FINAL DRAFT MINUTES

February 16, 2023 Standards Committee Meeting

RE: Minutes from the February 16, 2023 Standards Committee Meeting

E 809-ITCS-01 ITS TRAFFIC COUNT STATIONS INDEX AND GENERAL NOTES (revised draft)

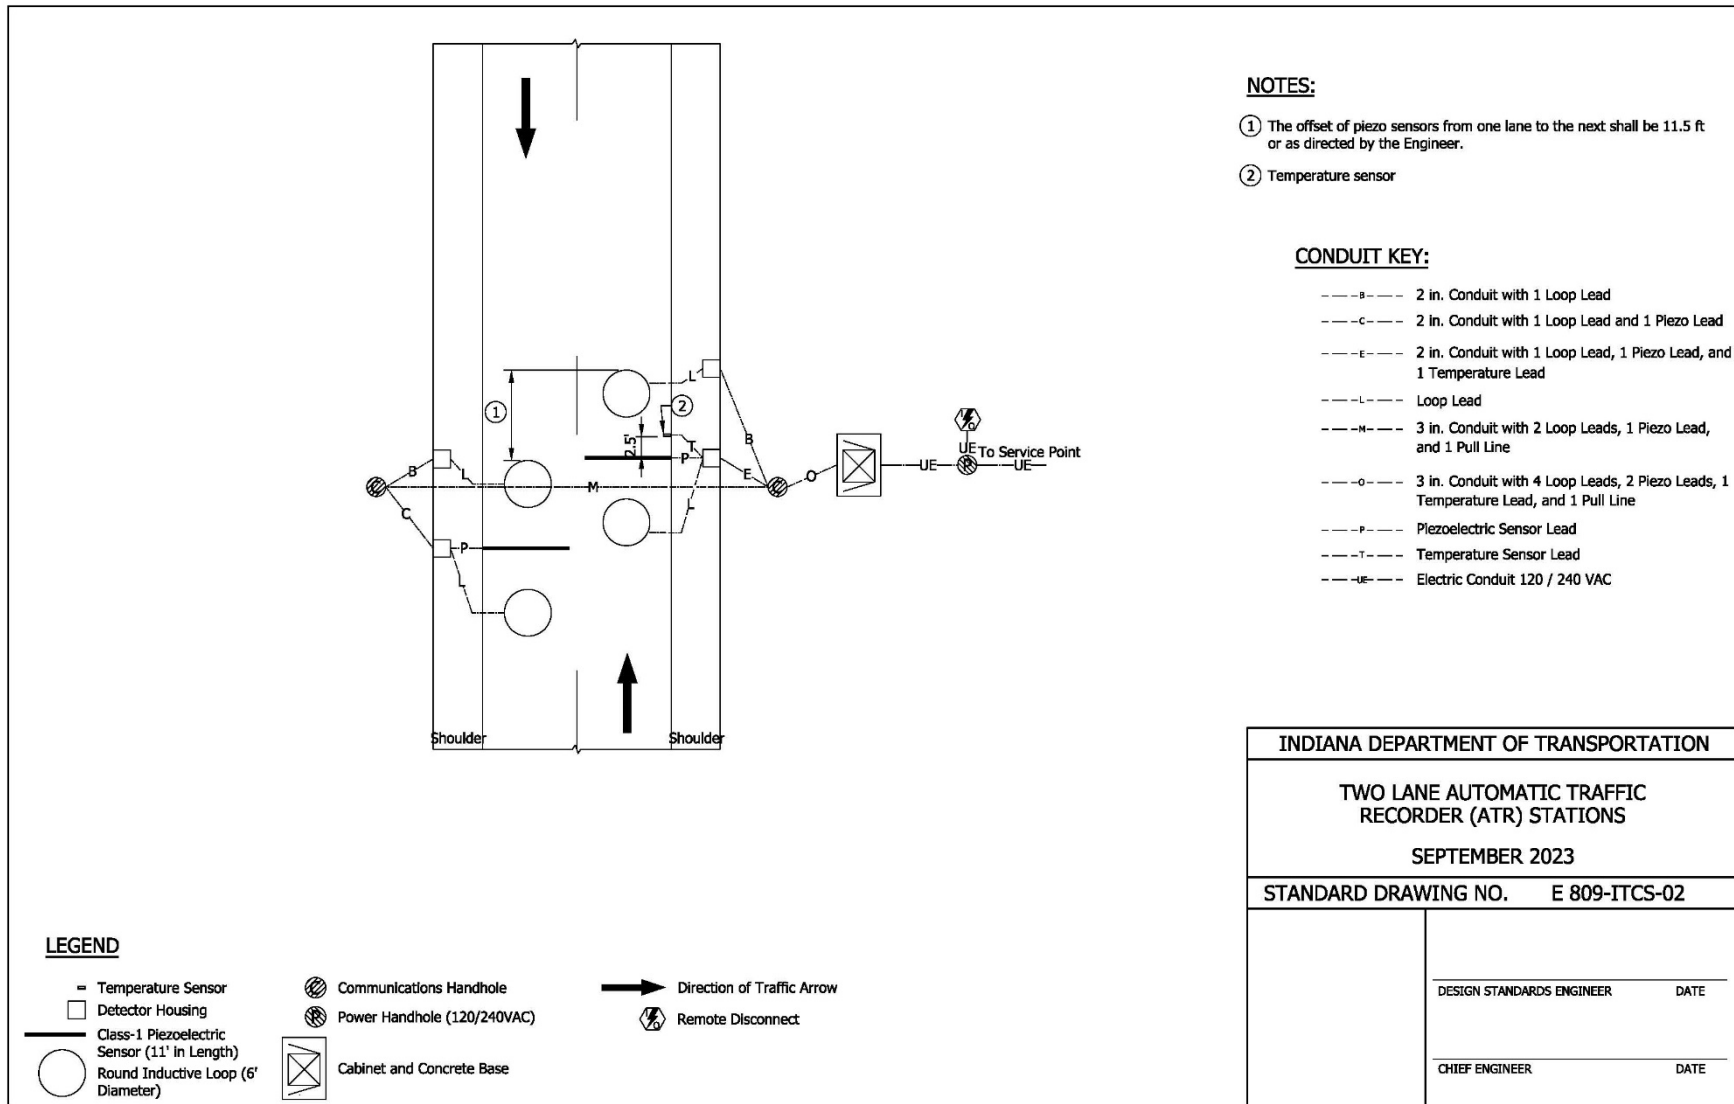
Mr. Koch stated, concerning drawing 809-ITCS-01: Referencing ASTM E 1318 is good design guidance, yet most will not read second level specifications. Horizontal & longitudinal alignment constraints should be addressed by the Designer. Also, what is the smoothness criteria for note #2? Please consider RSP 401-R-577.

Mr. Sorenson responded that we agree that the site selection criteria and geometric criteria of E1318 should be addressed by the designer, and we will make sure language similar to 401-R-577 is included in future contracts involving WIM sites to make clear to contractors our expectations. The smoothness criteria in note 2 was meant to be a general rule to assist designers in rough site selection (since it will be very difficult to meet E1318 specs at pavement transitions, for example), but if the E1318 spec is met so too will the criteria in note 2, so we will remove that note.

E 604-SWCR-11 MEDIAN CUT-THROUGH AND MEDIAN PERPENDICULAR CURB RAMP TYPICAL PLACEMENT (with shown markups)

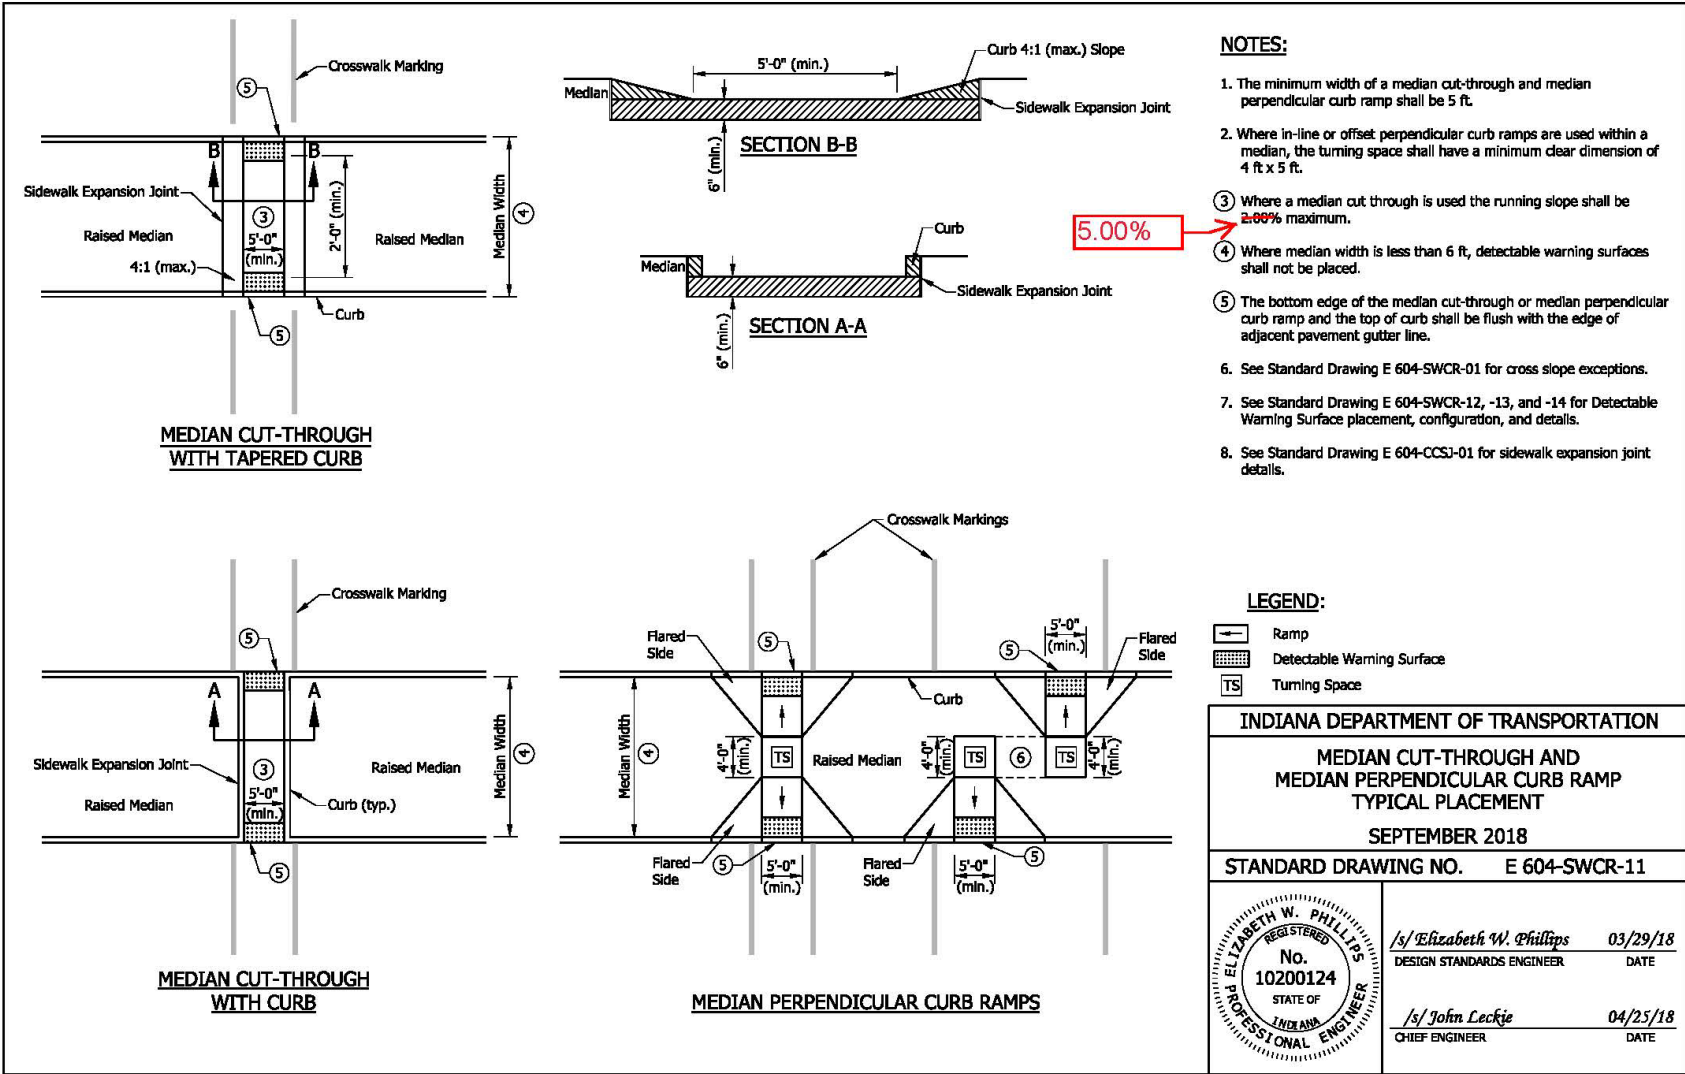
PROBLEM(S) ENCOUNTERED: Standard Drawing series 604-SWCR. Standard Drawing 604-SWCR-11, note 3, limits the running slope of a median cut-through to 2%. Upon further review of the Proposed Right-of-Way Accessibility Guidelines (PROWAG) and clarification from the US Access Board, the running slope may be a maximum of 5%. Given the geometry of divided highways and intersections, the increase of the maximum running slope will allow for more flexibility in design. Standard Drawing 604-SWCR-13, there has been some confusion on the offset of a detectable warning surface from a railroad crossing. The current drawing only takes into account a perpendicular crossing of a sidewalk, where many crossings are at a skew. When a railroad crosses a sidewalk at a skew, the designer and contractor must take into account the minimum and maximums within the Public Rights-of-Way Accessibility Guidelines (PROWAG) and the location of the railroad dynamic envelope.

This item was introduced and presented by Mr. Orton, assisted by Ms. Smutzer who stated that in Standard Drawing series 604-SWCR, Standard Drawing 604-SWCR-11, note 3, limits the running slope of a median cut-through to 2%. Upon further review of the Proposed Right-of-Way Accessibility Guidelines, PROWAG, and clarification from the US Access Board, the running slope may be a maximum of 5%. Given the geometry of divided highways and intersections, the increase of the maximum running slope will allow for more flexibility in design. In Standard Drawing 604-SWCR-13, there has been some confusion on the offset of a detectable warning surface from a railroad crossing. The current drawing only takes into account a perpendicular crossing of a sidewalk, where many crossings are at a skew. When a railroad crosses a sidewalk at a skew, the designer and the Contractor must take into account the minimum and maximums within the PROWAG and the location of the railroad dynamic envelope.

PROPOSED SOLUTION: Standard Drawing 604-SWCR-11, change note 3 to state, where a median cut-through is used the running slope shall be 5.00% maximum. Standard Drawing 604-SWCR-13, add a skewed railroad crossing detail, add dynamic envelope lines to both railroad crossing details, modify note 4 to define the dynamic envelope location, and add a note to give the minimum and maximum offset of a detectable warning surface in relationship to the dynamic envelope and the nearest rail.

Mr. Orton proposed to change note 3 in Standard Drawing 604-SWCR-11, to state where a median cut-through is used, the running slope shall be 5.00% maximum. And in Standard Drawing 604-SWCR-13, add a skewed railroad crossing detail, add dynamic envelope lines to both railroad crossing details, modify note 4 to define the dynamic envelope location, and add a note to give the minimum and maximum offset of a detectable warning surface in relationship to the dynamic envelope and the nearest rail.
